License to Operate On-Site Sewage Treatment and Disposal Facility

Permit of Authorization to Construct an On-Site Sewage Facility Permit Valid For One Year From Date Issued

RE: Septic Design #118134 522 Oak Trail Drive Tanglewood Shores, Lot 330 Canyon Lake, TX 78133 Tarango Residence

Olvera, Brandon

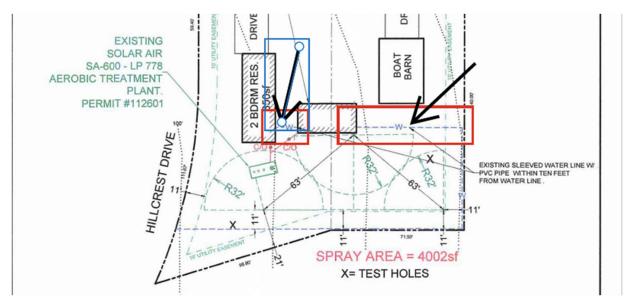
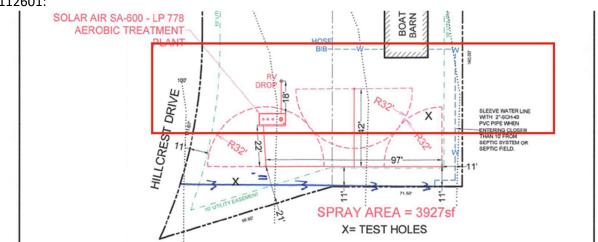
See attached screen shot from the original permit. I have marked the waterline that I am referring to. I understand that the line does not cross any part of the septic system, however it does encroach on the 10ft separation distance TAC285.91(10). Does the sleeving comply with TAC 290?

There are no bedrooms in the detached living/personal office.

The existing waterline goes under the detached living/personal office.

Water line does not cross any part of the septic system and is an existing sleeved line that was installed and inspected with permit #112601.
